CITY OF PORTSMOUTH

Memo

TO: Conservation Commission Members
FROM: Peter Britz, Environmental Planner 
DATE: April 12, 2018
SUBJ: April 18, 2018 Conservation Commission Meeting

175 Gosport Road

TAX MAP 224 LOT 1
SITE PLAN
 175 GOSPORD ROAD
 PORTSMOUTH, NEW HAMPSHIRE
 COUNTY OF ROCKINGHAM
 OWNED BY
MICHAEL CLARK
 SCALE: 1"=30' (22x34)
 1"=80' (11x17)
 FEBRUARY 21, 2018

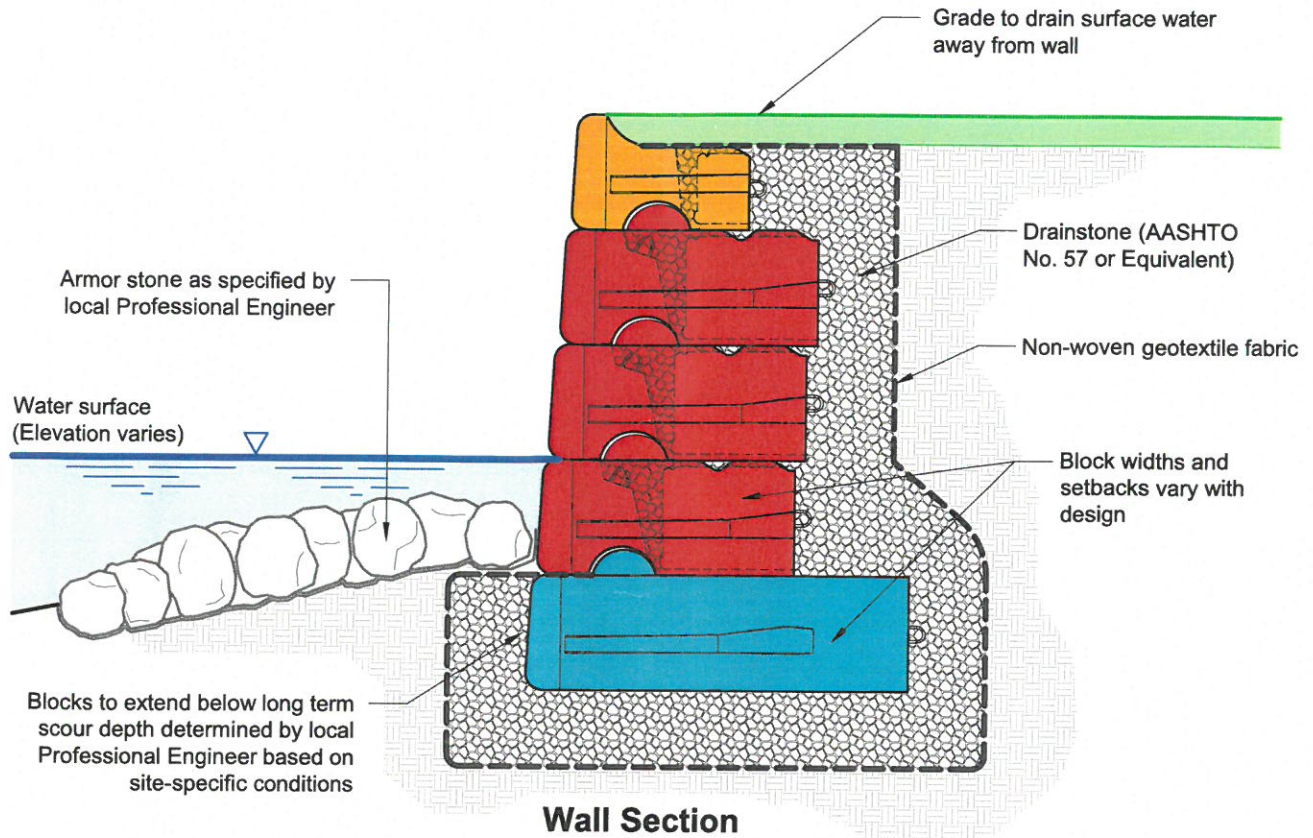
1. *The land is reasonably suited to the use activity or alteration.* The proposed parking area is located within the 100 foot inland wetland buffer zone and is sloped away from the freshwater wetland area. The grading plan clearly shows the water making its way off this area into a constructed swale to help move the stormwater away from the parking area providing treatment of this water before it reaches the tidal buffer zone. From a stormwater standpoint this is a reasonable approach for the expanded parking area. There is no information provided about the freshwater wetland. Given the loss of buffer function from a habitat standpoint it would be helpful if there were some buffer plantings proposed to offset the size of the new parking area within the buffer. Since the original submittal the applicant has revised the plans to include wetland buffer plantings along the border of the freshwater wetland area. On the site walk it became apparent the wall along the shoreline is failing and is holding back a lawn area. While the applicant has suggested replacing the retaining wall in kind removing the wall in favor of landscaping would provide a more effective tidal buffer in this area.

more natural transition could be accomplished with natural vegetation. Regarding the parking it is not clear if there are other places where the additional parking can be provided without impact to the inland wetland buffer. However, the applicant has proposed a lengthy treatment area for stormwater runoff from the proposed parking area which should offset the impact from the new imperious surface.

3. There will be no adverse impact on the wetland functional values of the site or surrounding properties. The grading proposed for the parking area has been designed to reduce stormwater impacts to the freshwater wetland and the addition of the swale will also reduce impacts to the tidal wetland areas. The loss of buffer area near the freshwater wetland could be offset with additional buffer plantings. While the replacement of the wall would not further impact the wetland buffer area, if the area where the wall is proposed were regraded and planted with natural vegetation this would provide enhanced buffer function.

4. Alteration of the natural vegetative state or managed woodland will occur only to the extent necessary to achieve construction goals. The location where the expanded parking is proposed is within an area that is currently paved. While there will be some new pavement there is currently an area of pavement existing and additional pavement will be removed from the area just outside of the 100' inland wetland buffer to create this new parking area.

5. The proposal is the alternative with the least adverse impact to areas and environments under the jurisdiction of this section. The applicant has taken steps to reduce the impact in the buffer. The design of the parking area and associated swale will help reduce the stormwater impacts from the new project. Since the original application was submitted the applicant has proposed additional wetland buffer plantings bordering the freshwater wetland and pond area to enhance the buffer function of this area. After viewing the wall on the site walk the topography of this part of the site became more clear. The retaining wall represents a steep transition between upland lawn and intertidal area. Repair of this wall with a natural landscaping approach would provide an improved transition between the upland and wetland area and could serve as an enhanced wetland buffer area.

Recommendation: The application shows an impact of 6,120 square feet of impact in the inland wetland buffer. Of this impact some is existing structure and pavement. The applicant has provided an effective means of treating stormwater from this inland wetland work and has provided additional buffer plantings to enhance the freshwater wetland area. The site could be further enhanced by replacing the proposed retaining wall with a natural buffer transition area and tidal buffer plantings. Staff recommends the applicant develop an alternative plan to the proposed retaining wall to allow for a more natural landscaped transition to the tidal area.

Given the enhanced freshwater wetland buffer plantings if the applicant were to replace the proposed wall with a more appropriate tidal buffer planting area and followed the City's requirements by not using pesticides in the wetland buffer and not using fertilizer in the first fifty feet of the wetland buffer and using only low phosphate and slow release nitrogen fertilizer between 50 and 100 feet of the wetland areas staff believes this project could enhance both the tidal and freshwater wetland buffer areas.

Conceptual Seawall Detail

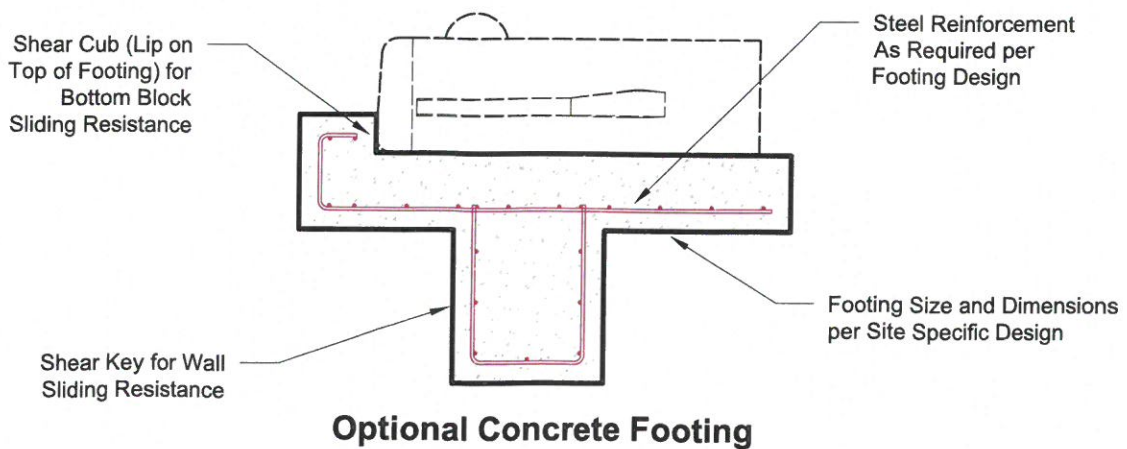
2. *There is no alternative location outside the wetland buffer that is feasible and reasonable for the proposed use, activity or alteration.* With regard to the replacement of the dock and retaining wall these are existing features being replaced. The dock replacement is an allowed use according to Article 10 section 10.1016.10 *Permitted Uses* where number (3) states: "The construction of piers or docs, provided that all required local state and federal approvals have been granted." The applicant is applying for a state wetland permit concurrent with their wetland conditional use application. Given the location of the existing dock it appears as if the proposed dock crosses the extended property line of the abutting property. This will be an important component of the review of the state wetland permit application. The applicant has stated they need to replace the retaining wall to protect their property however it appears as if with some grading a

6. Any area within the vegetated buffer strip will be returned to a natural state to the extent feasible. The applicant has provided an area near the freshwater wetland which will be planted with additional buffer vegetation. In addition it would be a benefit to the tidal wetland if the applicant would consider creating a natural buffer area in place of the existing retaining wall. Not only would it improve buffer function with the tidal/ upland transition area it could be designed to allow easy pedestrian access to the waterfront and reduce future potential impacts from wall failure in the case of severe storms.
